# COTTAGES AT GENERATION VILLAGE

## WILLARD, GREENE COUNTY, MISSOURI

PM: RS  
PC: RS  
PLAN SET NO. \_\_\_\_\_  
MASTER COVER SHEET  
ADDENDUM #2

ISSUE/REVISIONS  
12 AUG 2022 ISSUE SET  
03 NOV 2022 ADDENDUM #1  
22 SEP 2023 ADDENDUM #2

3-BR UD HOUSE FINISH PLAN  
SCALE: 1/4" = 1'-0"

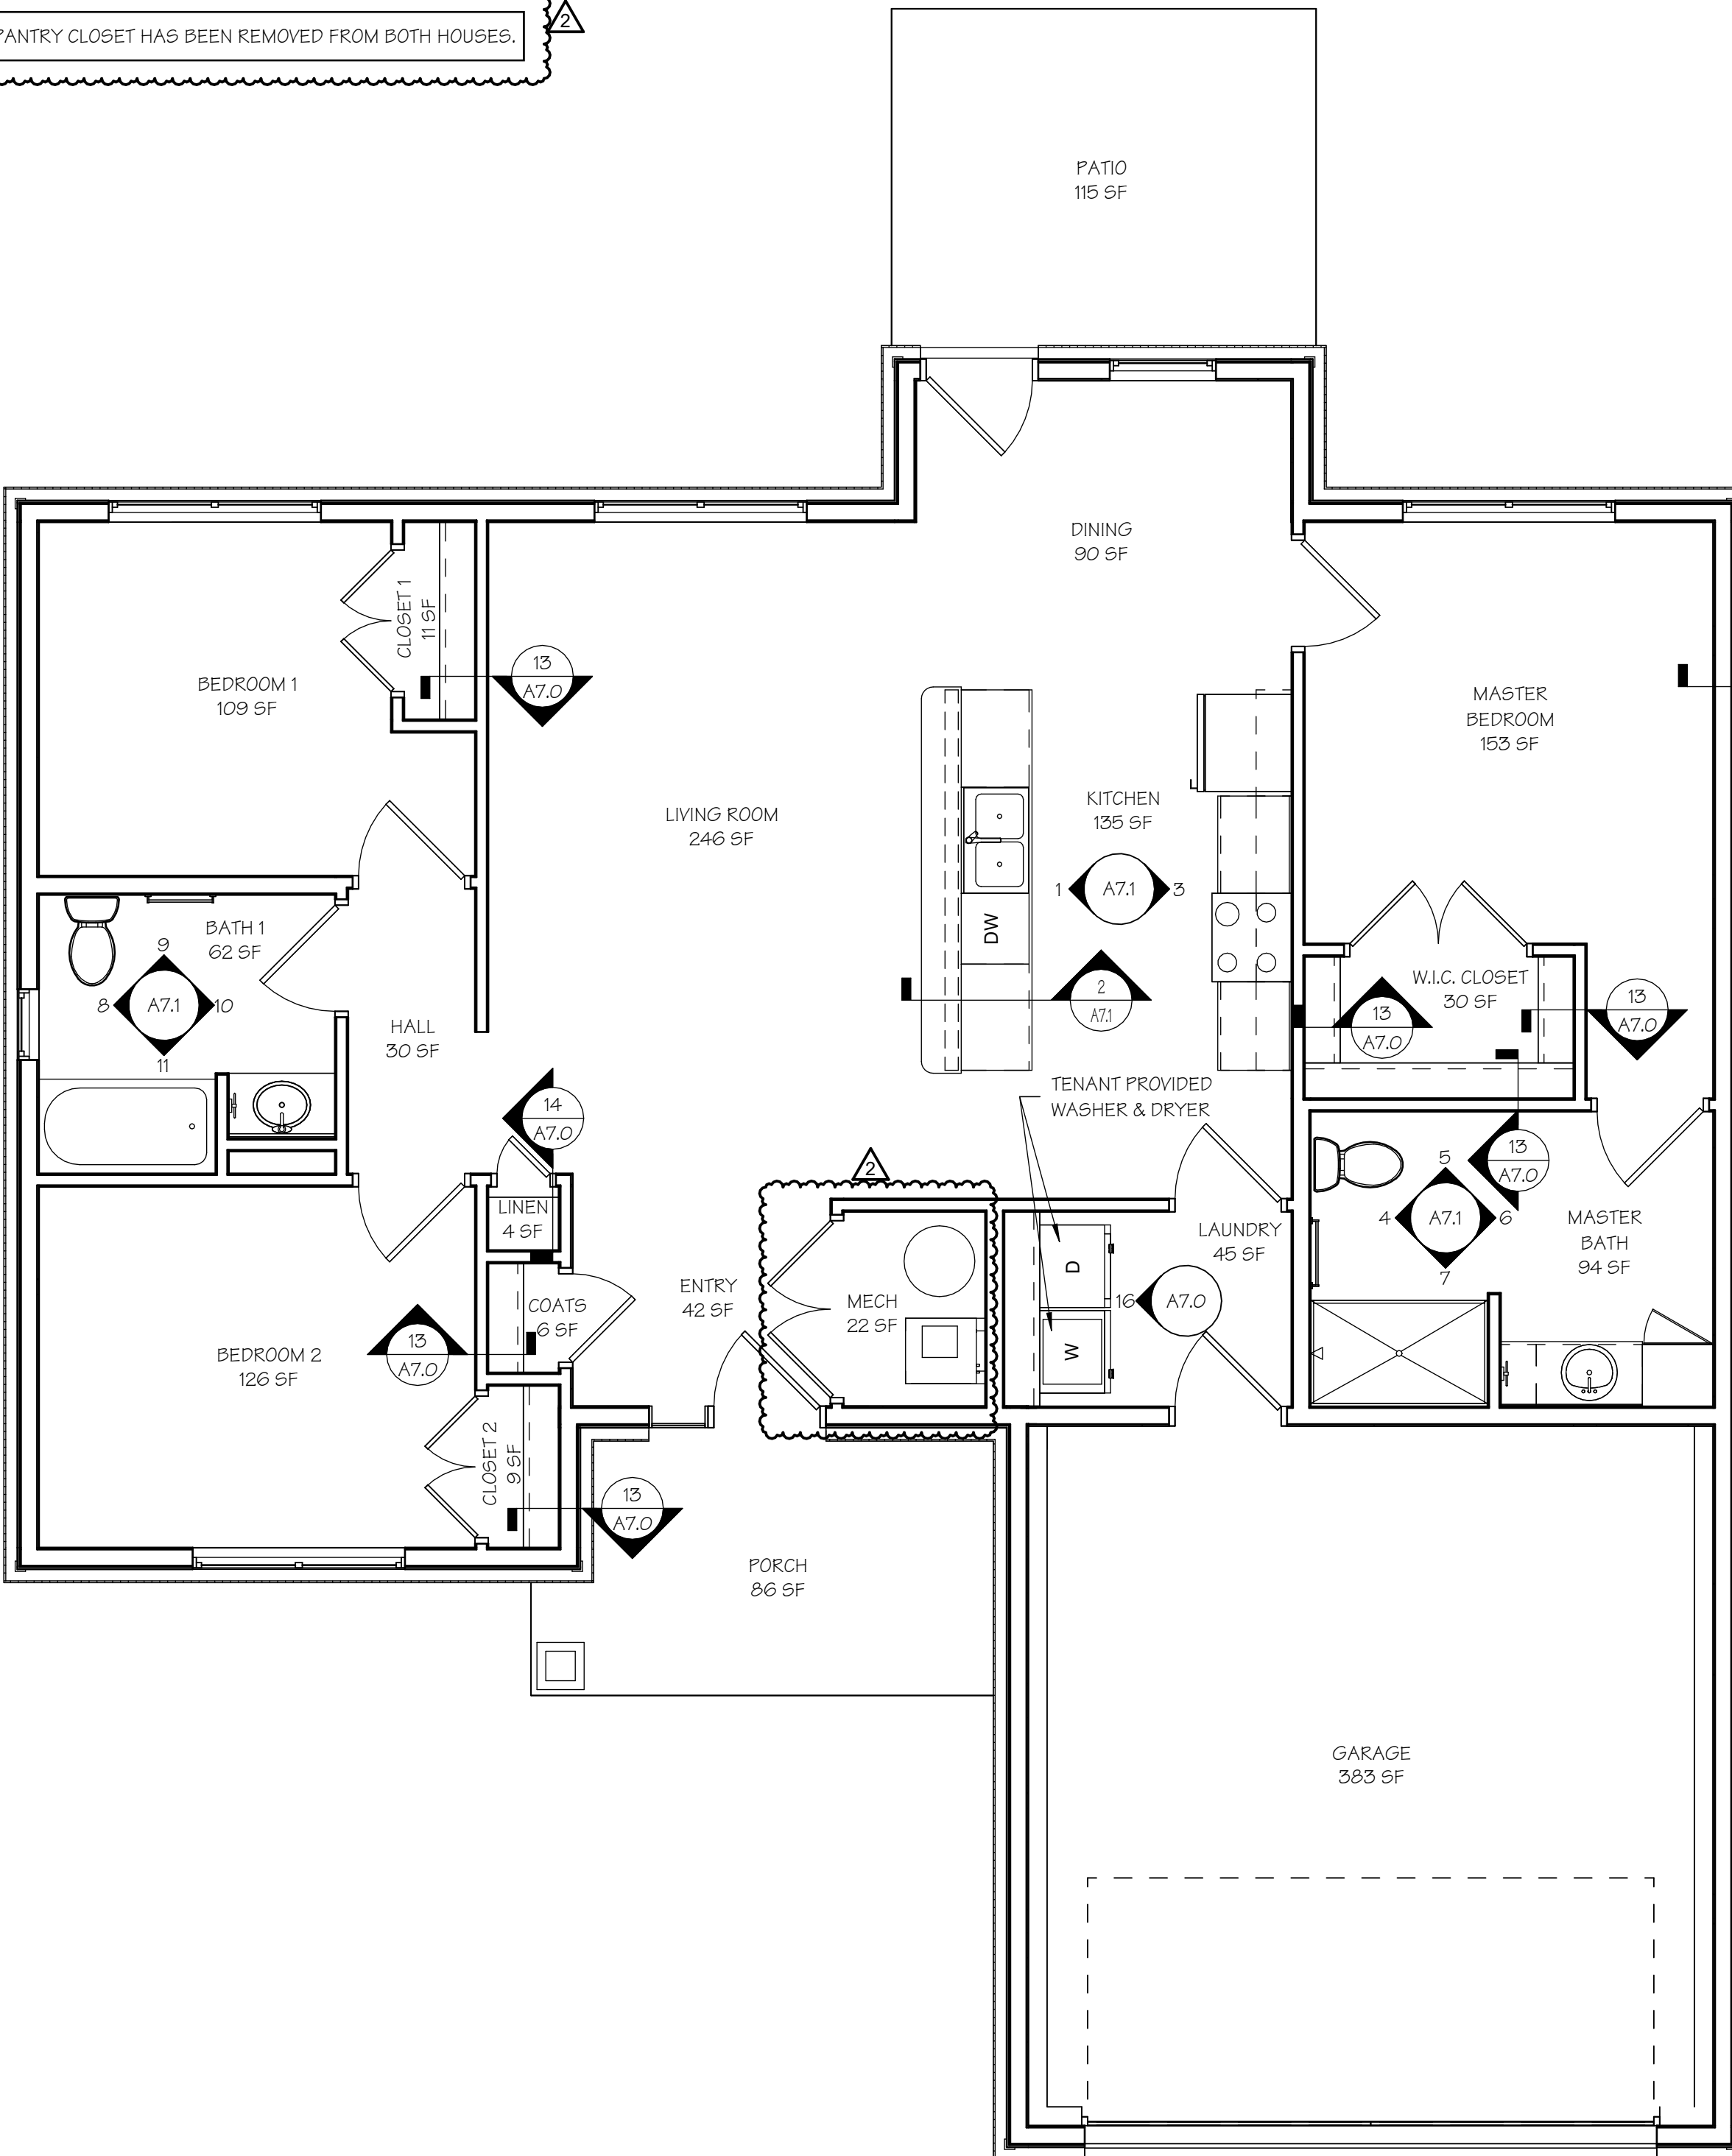
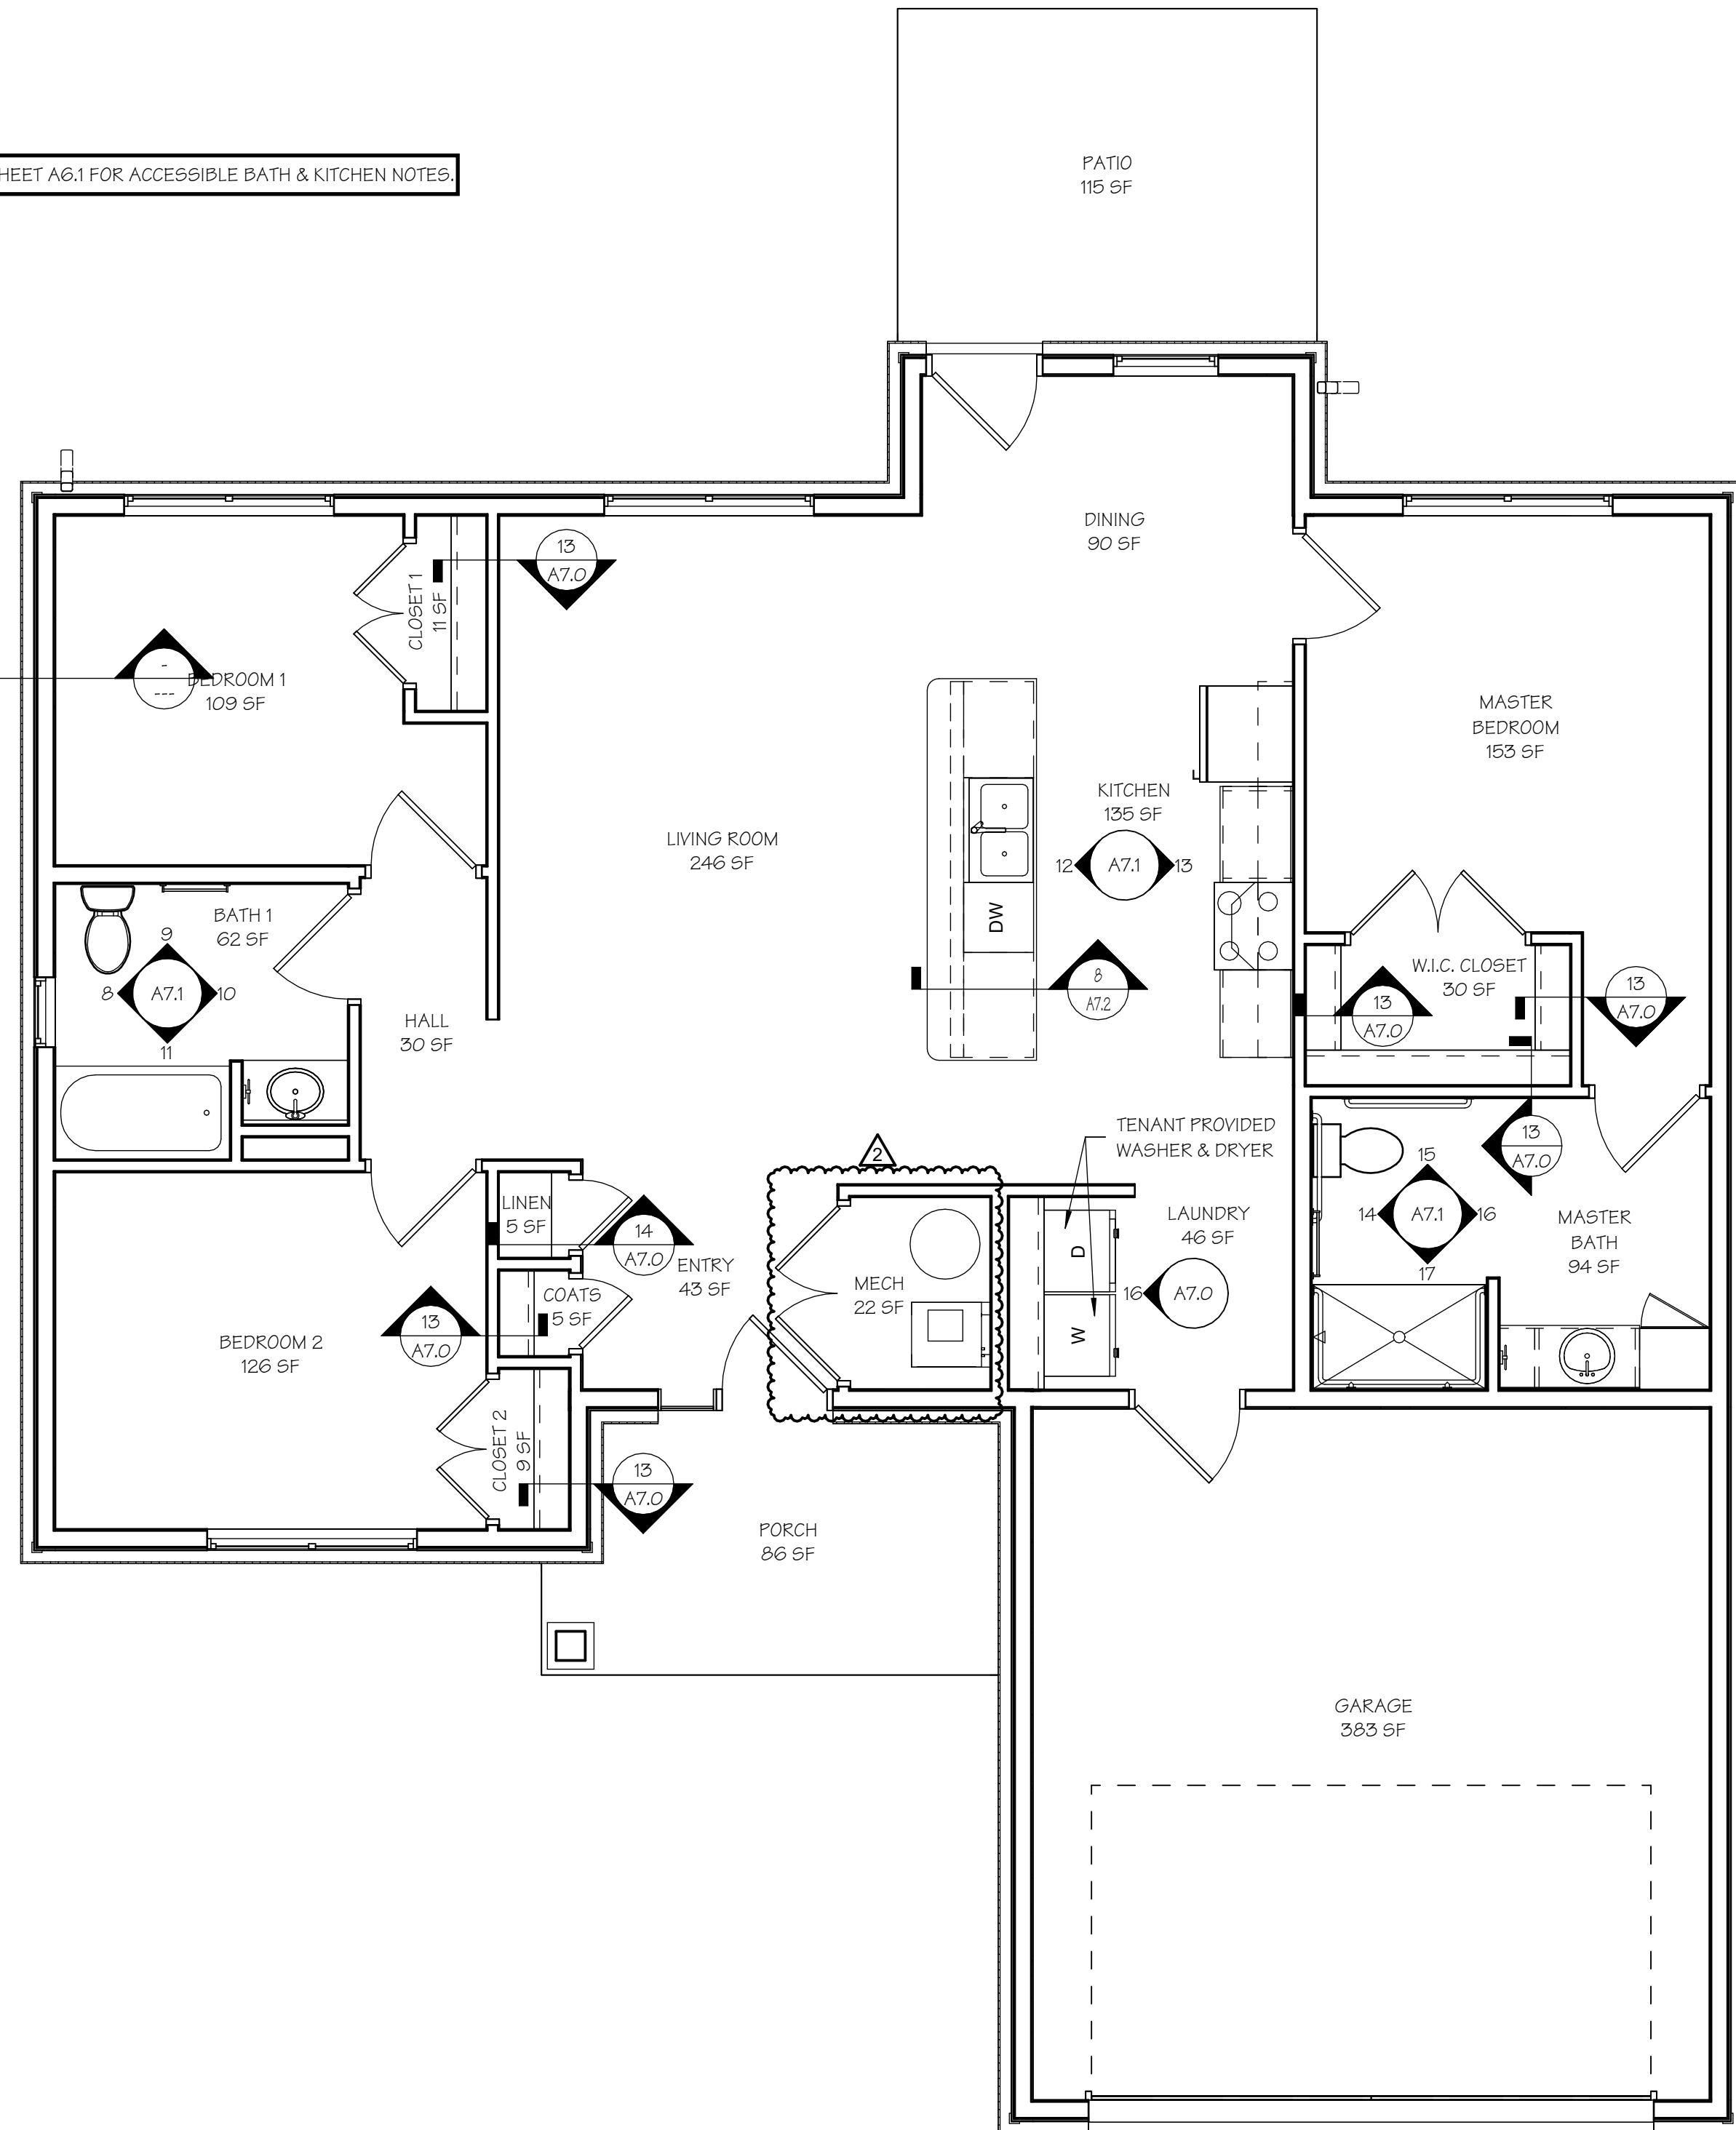
NOTE: PANTRY CLOSET HAS BEEN REMOVED FROM BOTH HOUSES.
